Risø-I-2521(EN)

# Burgos Wind Farm Project

## The Philippines

### Technical Desk Review

Figure 4 Wind resource map of Gross AEP with directional distributions and wake losses at turbine positions.

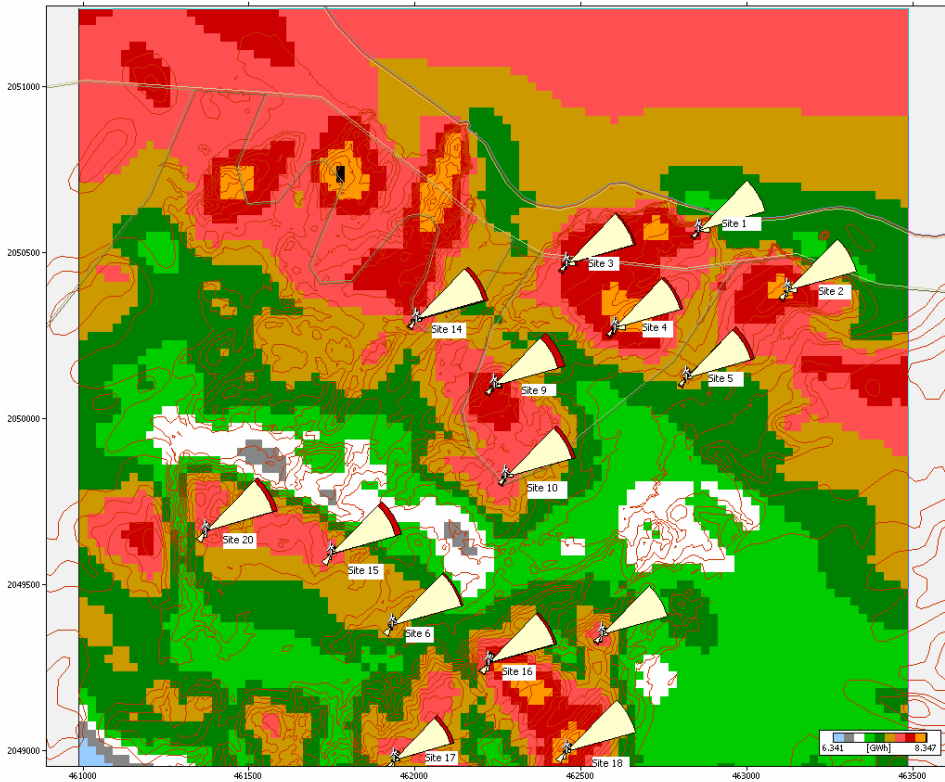
Figure 4 shows a wind resource map of gross AEP for a Vestas V80 2 MW turbine with 67m hub height. Also shown are the directional AEP distributions at the turbine positions with correction for wake losses. The layout is a reasonable compromise between having turbines near local optima in the spatial wind resource distribution and keeping a proper distance between the turbines. Further optimization might be possible, e.g. by moving turbine site 1 westward near a local optimum or moving

turbine 9 backward to reduce its relatively high wake loss. These adjustments will only be fine-tuning since the turbine AEP are not too different, see Figure 5
